April 1, 2009 Changes to the Uniform Dwelling Code

The following is a summary of changes in the revised Uniform Dwelling Code (UDC), SPS 320-325, **effective April 1, 2009**. The UDC is generally applicable to one- and two-family dwellings originally built after June 1, 1980, except for energy requirements that began December 1, 1978. (Municipalities may adopt the UDC or some other code to apply to alterations and additions to older dwellings.) These changes have been reviewed and approved by the Dwelling Code Council, a governor-appointed advisory council composed of builders, designers, code officials, labor representatives, subcontractors and others. Refer to the official code for details of the code. That code will be free online after it is revised electronically, <http://www.dsps.wi.gov/sb/sb-divcodeslisting.html>, or can be purchased from state Document Sales, <http://dsps.wi.gov/SB/SB-DivCodesObtain.html>

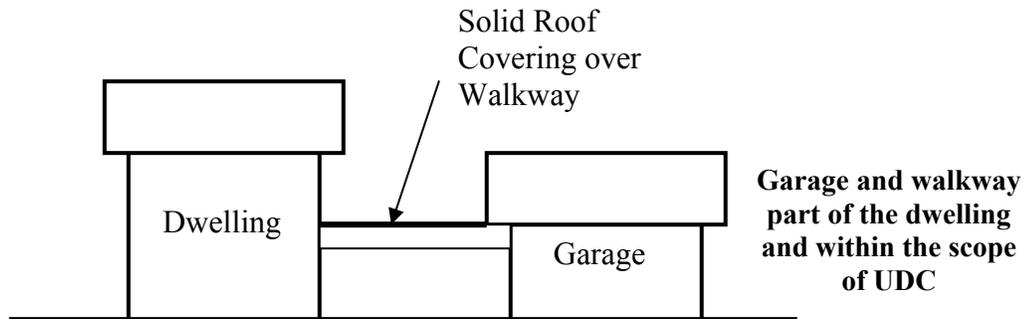
5. 320.05(6) – Clarifies that only those farm buildings not used for habitation are exempt from the UDC.
6. **320.05(9)** - Exempts from the UDC, those motor homes and recreational vehicles that are, or have been, titled by the Wisconsin Department of Transportation (DOT). Note that in order to be titled by DOT, recreational vehicles require a towbar (hitch), chassis, axles and wheels for transportation. At the installation site, the chassis and axles shall remain on the unit, with the towbar (hitch) and wheels left at the site. Otherwise the unit, including a so-called park model, is subject to the UDC.

Additionally, any additions, with a roof, to a motor home or recreational vehicle are considered dwellings that shall comply with the UDC.

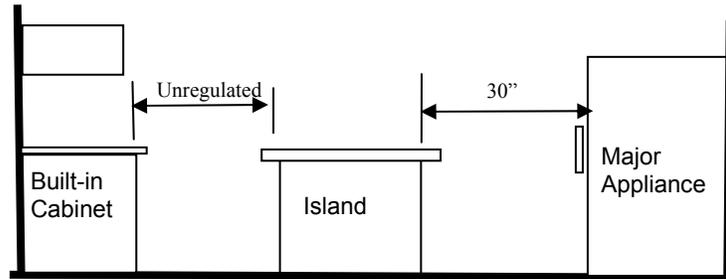
29. 321.035(1)(c)2. Requires that if there is a full bathroom on the first floor, then it shall have the minimum doorway widths per this section.
30. 231.035(2) Clarifies that you may infringe 4.5 inches on both sides into the 36" minimum width of a hallway. Higher than that, infringements are unlimited.

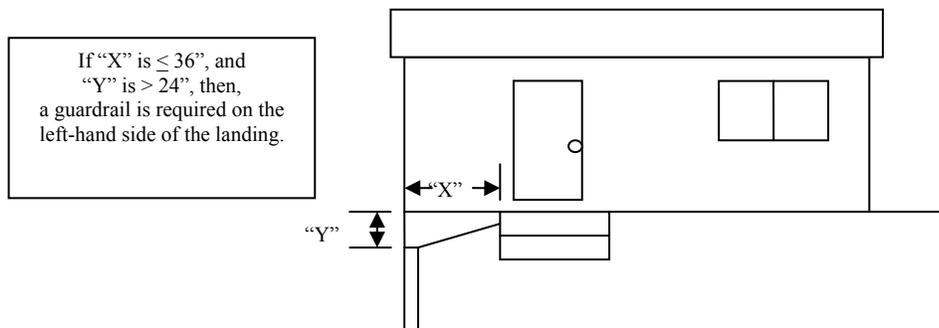
38. **321.04(3)(c)1.c.** Clarifies that the 24 inch vertical drop-off measurement that triggers guardrails is taken from the lowest point within 3 feet horizontally of the edge of the landing, deck, porch, etc.

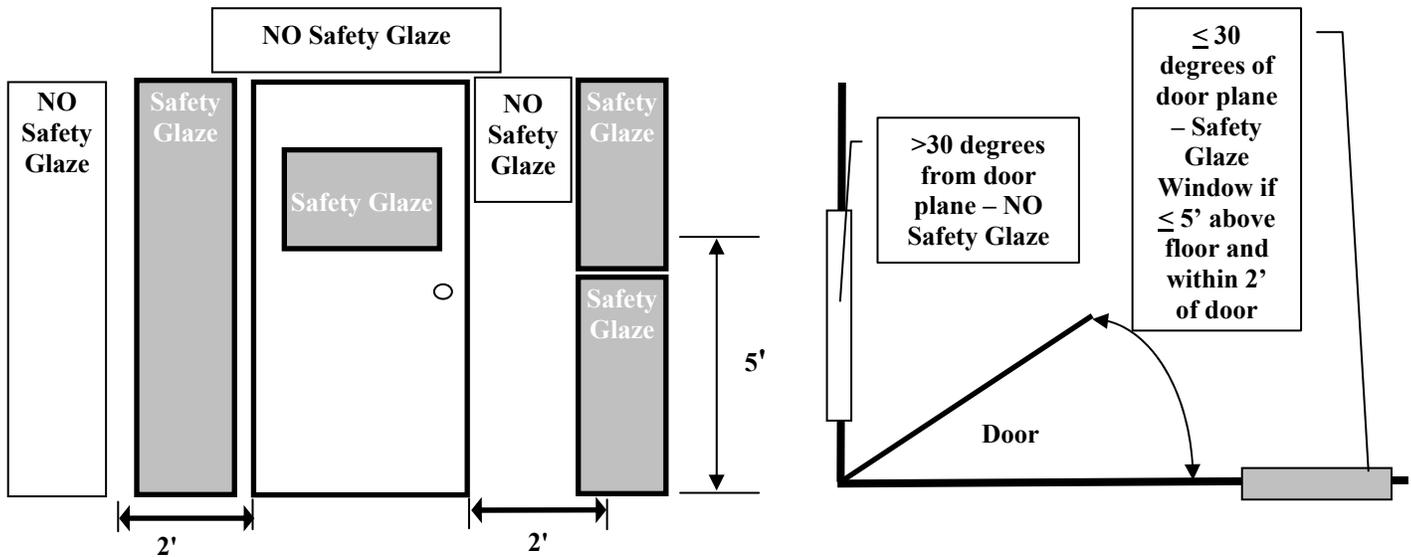
40. 321.05 (3) (a) Modifies the safety glazing requirements so that it is required for a sidelight or glazing that is within 2 feet horizontally of the door and is within 5 feet of the floor and is in a plane within 30 degrees of the plane of the closed door.

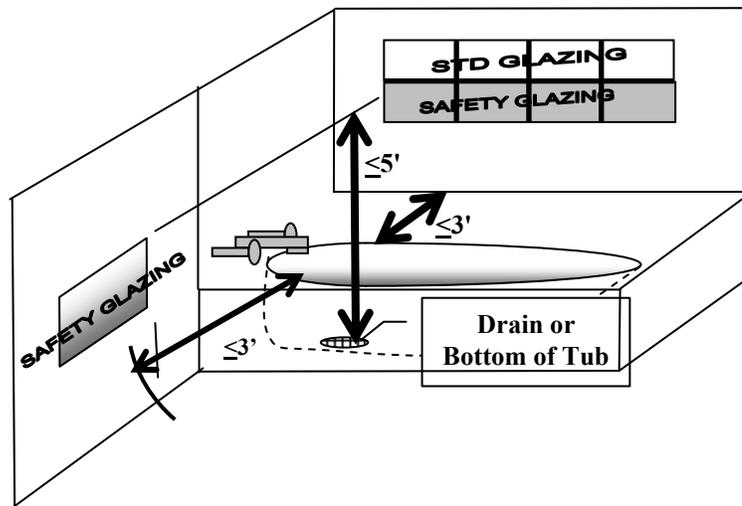
41. 321.05(3)(b) Expands the safety glazing requirement beyond the "tub or shower enclosure" for any glazing within 3 feet of the inner rim of the tub or shower and 5 feet vertically from the drain.

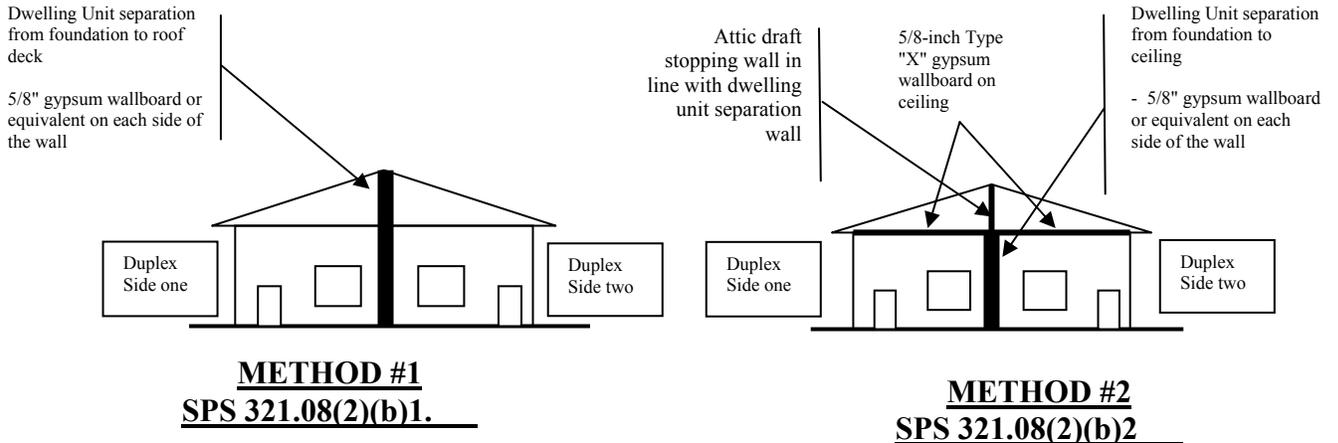
42. 321.08(1) (intro. & Table) Changes fire separation requirements for zero-lot line dwellings to only require one shared wall rated for the equivalent of one hour.
43. 321.08(1)(a)4. Repeals the statement that adjoining garage units are not required to be separated from each other. (In most cases this will still be acceptable, except where the dwelling unit separation in a duplex is placed between adjoining garage units.)

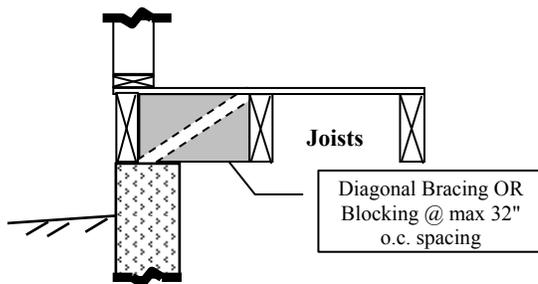
55. 321.16. Adds an exception to allow the use of a frost protected shallow foundation that is installed in accordance with ASCE -32 as adopted in table SPS 320.24-5. The division also accepts designs in accordance with the U.S. HUD “Design Guide for Frost-Protected Shallow Foundations” available for free download from www.huduser.org/publications/destech/desguide.html .
56. **321.17(1)(b)2. Adds a requirement that if a partial drain tile system is provided, it must have a means to discharge water from the tile or pipe to a sump pit, a crock or daylight.**
57. **321.17(3)(d)1. Adds an exception for not providing exterior drain tiles around foundations serving walkout basements.**
58. 321.18(1)(d)2.b. Includes floor joist bridging, along with solid blocking, as a bracing means for foundation walls that are parallel with the floor joists.

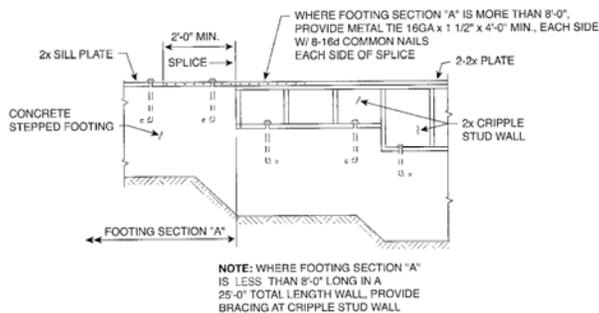
69. **321.25(8) and (9).** Expands bracing requirement for dwellings. In addition to requiring bracing at the corners, bracing will be required at no more than 25 foot intervals in the braced wall line and braced wall lines will need to be provided and spaced no more than 35 feet o.c. An exception is provided to permit the walls to be spaced up to 50 feet

- o.c. This section also includes a note permitting the alternative use of wall bracing provisions, s. R602.10, of the 2009 International Residential Code (IRC).**
